**ADDRESS: 449 LOCUST AVE**

Proposal: Rehabilitate designated house and construct addition

Review Requested: Final Approval

**STAFF RECOMMENDATION:** Approval, with reconsideration of the lengthening of the third-story arched windows of the main block, with the staff to review details, pursuant to Standards 2 and 9.

THIRD FLR PLAN

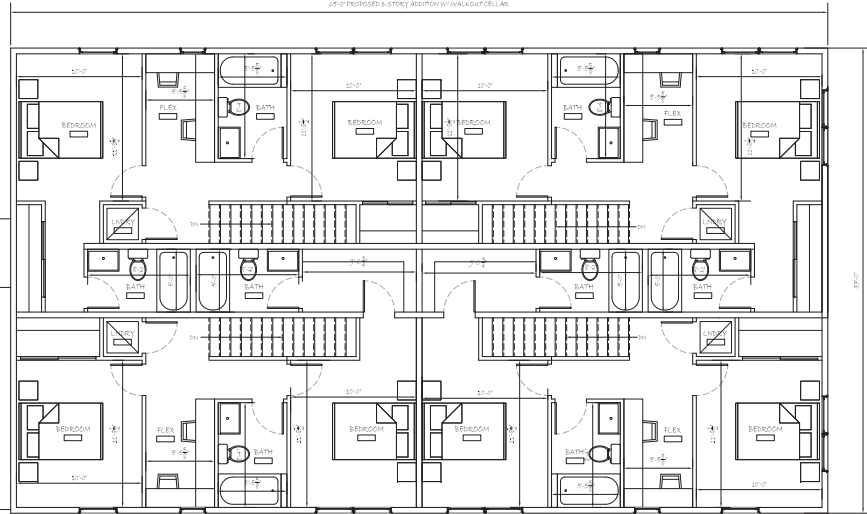
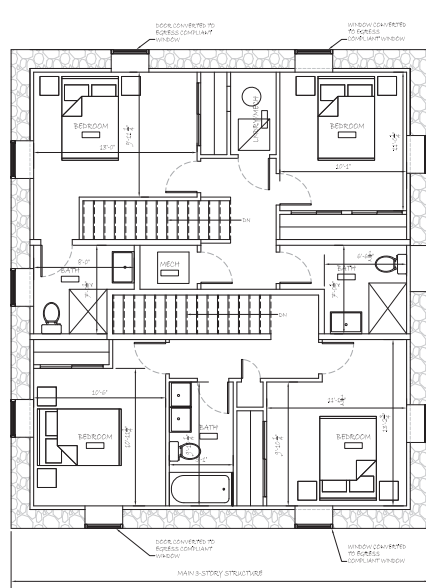
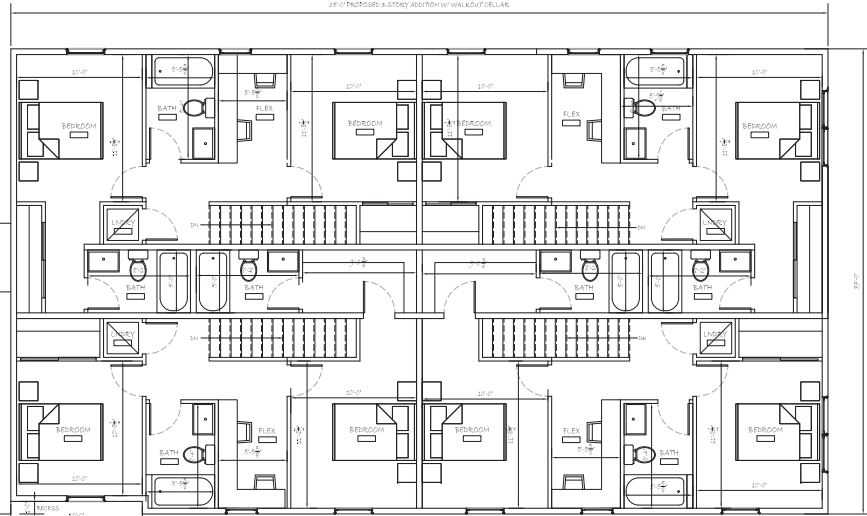
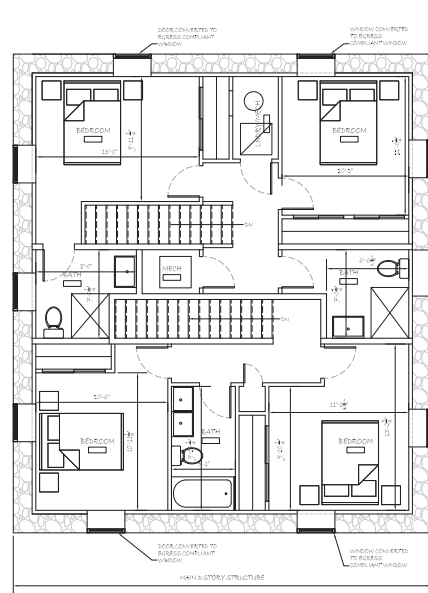
- The top sash of the paired, arched windows on the third story of the main block's north and south facades will be restored but lower sash will be added to lengthen these windows.

- Comments and notes from front elevation view (for cupola, roof, lantern, porch columns) are carried into this side view as well.
- 3<sup>rd</sup> floor double archtop windows have been revised (reduced height) to match the existing double archtop window size found in the front of the building.

- Comments and notes from front elevation view (for cupola, roof, lantern, porch columns) are carried into this side view as well.
- 3<sup>rd</sup> floor double archtop windows have been revised (reduced height) to match the existing double archtop window size found in the front of the building.
